SUBJECT: DRAFT SER INPUT FOR BEAVER VALLEY UNIT 2

Plant Name: Beaver Valley Unit 2  
Docket No.: 50-412  
Licensing Stage: OL  
Responsible Branch: LB #3  
Project Manager: L. Lazo  
Site Analysis Branch Reviewer: C. Ferrell  
Requested Completion Date: January 27, 1984  
Review Status: SER Review Complete

## BEAVER VALLEY UNIT 2

## DRAFT SER INPUT

FIGURE 2.4

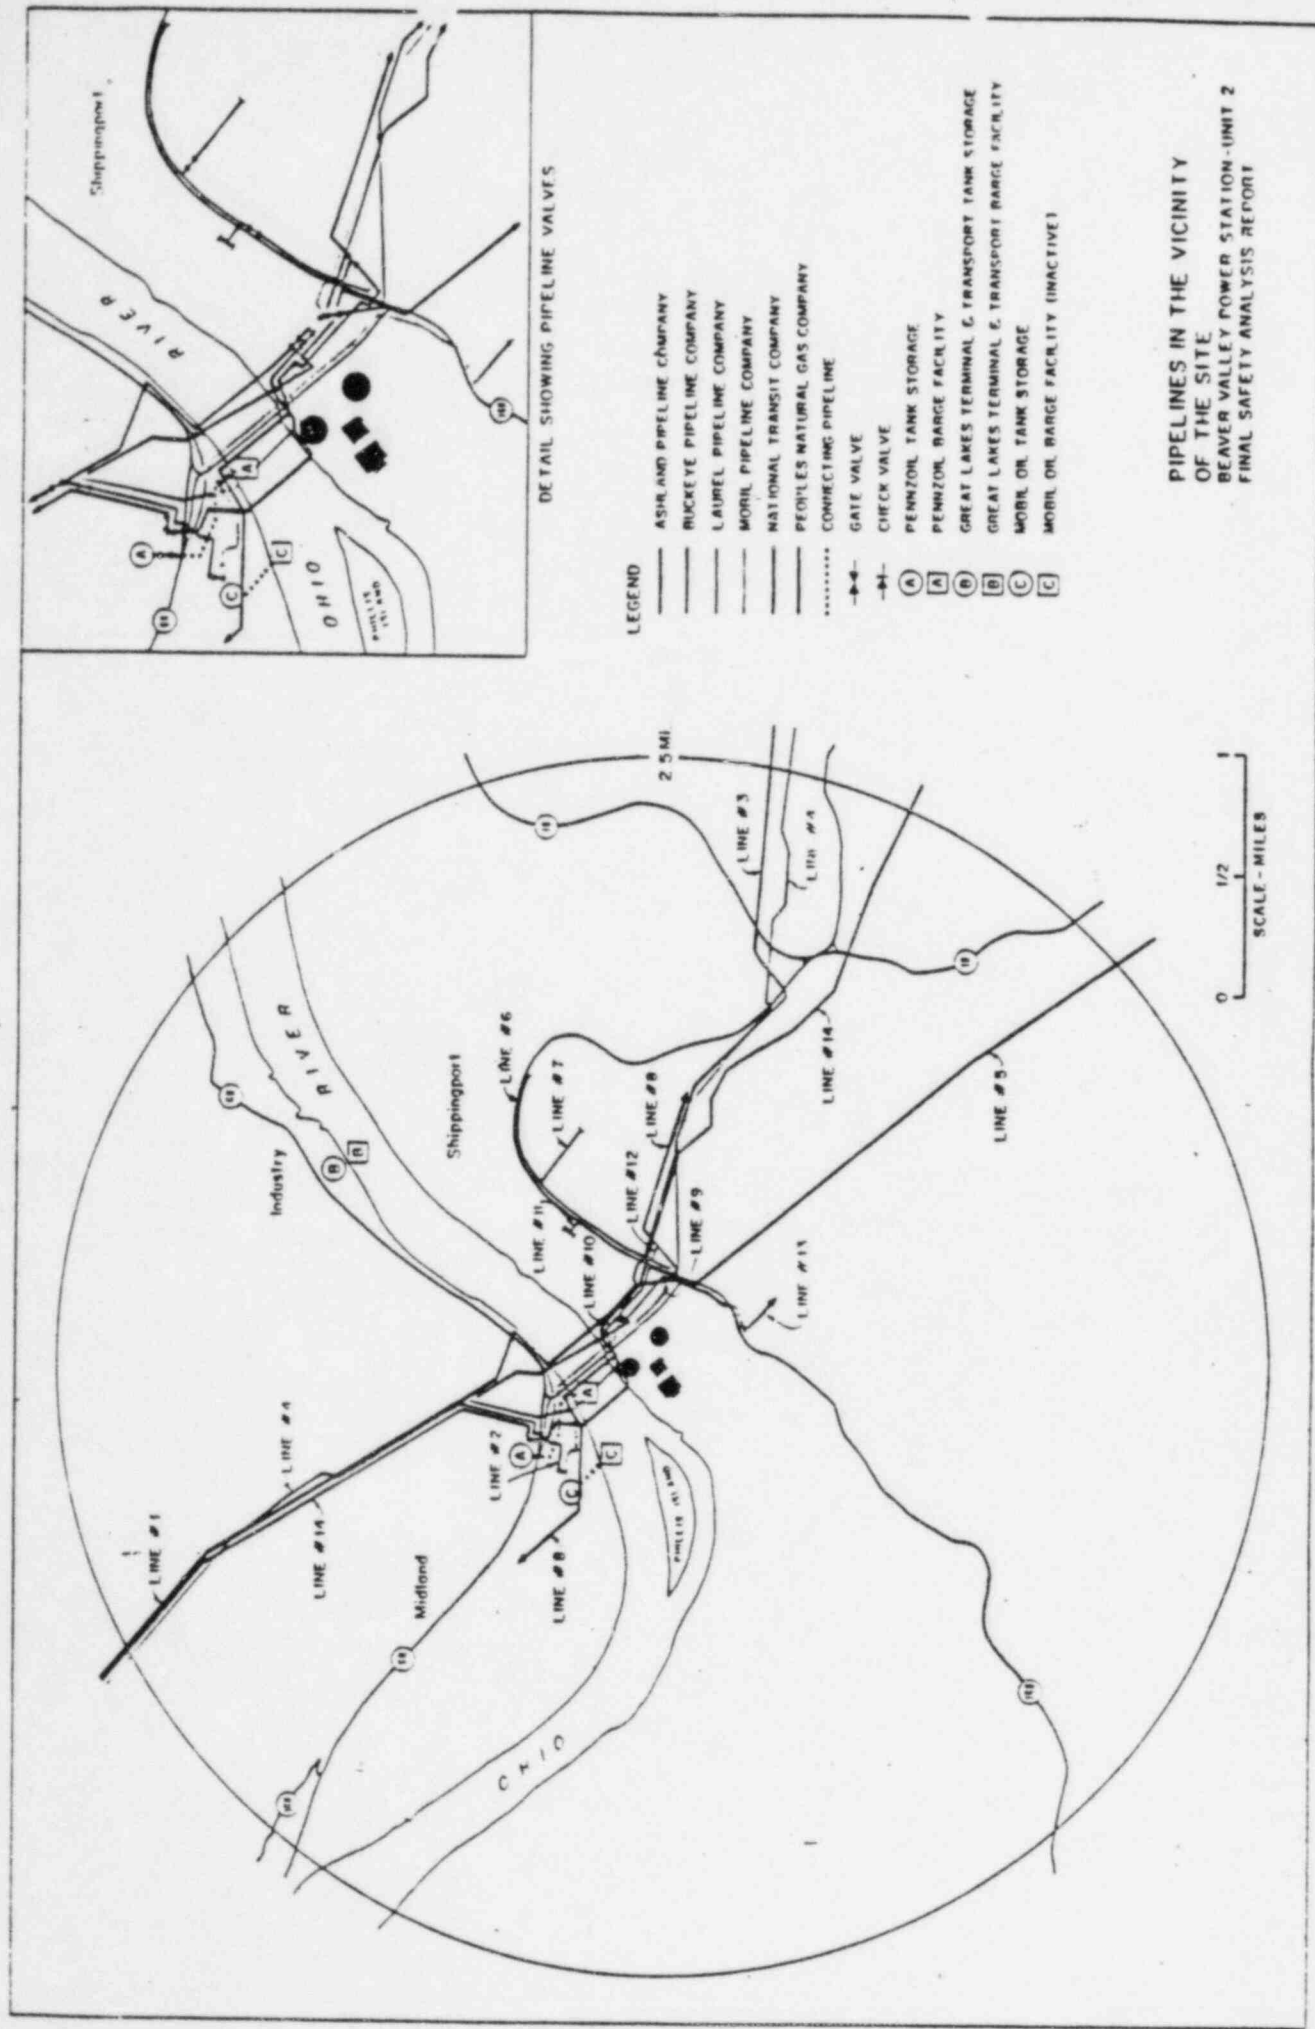
There are no military installations or missile sites within 10 miles of the Beaver Valley site. There are 13 pipelines which pass through or near the Beaver Valley site (See Figure 2.4). Six of these pipelines pass through the exclusion area on the northeast side.

The 12" natural gas pipeline was relocated during the construction permit review. The 8" Mobil Oil pipeline, which currently carries gasoline, kerosene and heating oil, has also recently been relocated further away from Beaver Valley Unit No. 2 reactor (See Figure 2.4, Line #13). The applicant has confirmed that the pipeline will not be used for LPG. Figure 2.5 shows a more detailed drawing of the routing of this pipeline through the Beaver Valley plant site. The current routing is on the east side of the earthen embankment of Route 168 bridge, approximately 950 feet from the Unit No. 2 diesel generator building.

The staff, after reviewing the topography of the Beaver Valley site area, determined that there is additional means for gasoline vapor to enter the Beaver Valley exclusion area closer to the Beaver Valley Unit 2 safety related structures than what was postulated by the applicant. A break in the Mobil Oil pipeline on the hillside southeast of the plant could drain into Peggs Run, which flows through the site between the cooling towers and the Route 168 bridge. The applicant was requested to review this scenario and evaluate the consequences. They determined that a double-ended rupture of the pipeline on the hillside above Peggs Run could release a maximum of 23,380 gallons of gasoline. The terrain topography surrounding the pipeline favors the drainage of gasoline directly into Peggs Run. The run-off of gasoline into Peggs Run would flow into a 15 foot diameter culvert 1800 feet long. This culvert exits into a ravine that is about 45 feet below plant grade. The drainage from Peggs Run then flows between the Unit 1 cooling tower and Route 168 for approximately 1000 feet before entering the Ohio River. Peggs Run passes within 550 feet of the east wall of Unit No. 2 diesel generator building. The applicant has investigated an explosion of gasoline vapor in the culvert and has determined that although the manhole covers could become missiles with a range of about 70 feet, plant safety would not be endangered since the Unit 2 diesel generator building is approximately 600 feet from the closest manhole location (See Figure 2.7). The applicant evaluated a gasoline vapor explosion in the Peggs Run ravine east of the Unit 2 diesel generator building. The evaluation indicates that, without considering the shielding effects of the ravine, the peak reflected overpressure on the building would be no more than 2.8 psi. Independent calculations by the staff indicate a peak reflected overpressure of 1.0 psi. The above overpressures are within the design basis overpressure of 3 psi for the plant due to tornado wind load considerations.

The staff concludes that even considering an off-site break in the Mobil Oil pipeline, the relocated pipeline will not present a danger to safety related structures at the Beaver Valley site.
